CONTRACTOR'S SUBMITTAL TRANSMITTAL

FROM CONTRACTOR	CONTRACT NO. 81-C-1766	TRANSMITTAL NO. 86	DATE May 22, 1984
TO Trader Construction Company	PROJECT TITLE AND LOCATION Public Works MCB Camp Lejeune, N.C.		
Lockwood Greene/Six Associates

ITEM NO.	PROJ. SPEC. SECT. & PARA. and/or PROJ. DWG. NO. *	ITEM IDENTIFICATION (Type, size, model no., Mfg. name, dwg. or brochure number)	NO. OF COPIES	ACTION CODES **	REVIEWER'S INITIALS CODE AND DATE
152	10801	Metal Toilet & Bath Accessories			
		Catalog Data: Stainless Steel Frame Mirror	7	AN/C	A.B. 1 June 84
		Surface Mtd. S.S. Paper towel dispenser	7	A	
		Grab Bar	7	A	
		Stainless Steel Shelf	7	A	
		Surface Mounted Toilet Tissue Holder	7	A

STAINLESS STEEL CHANNEL FRAME MIRROR W/SHELF

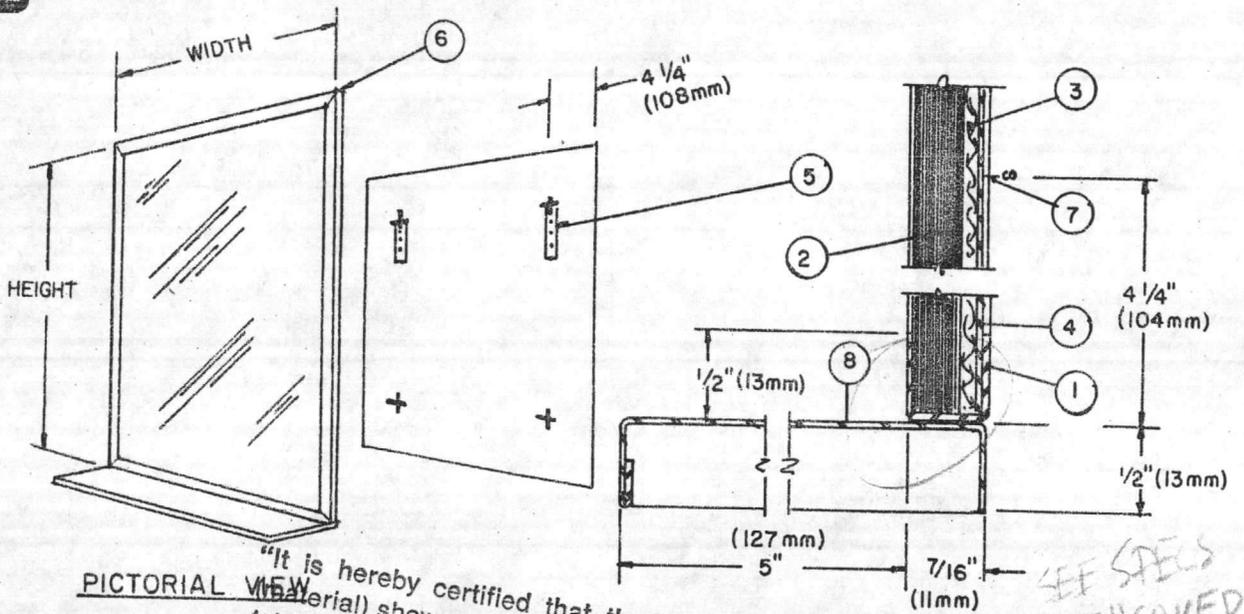
- 1) Shelf does not comply with specifications regarding coved bottom.
- 2) Shelf thickness shall be .050 inch (18 ga.).

SEE SPECS RE "COVERED BOTTOM" A/E
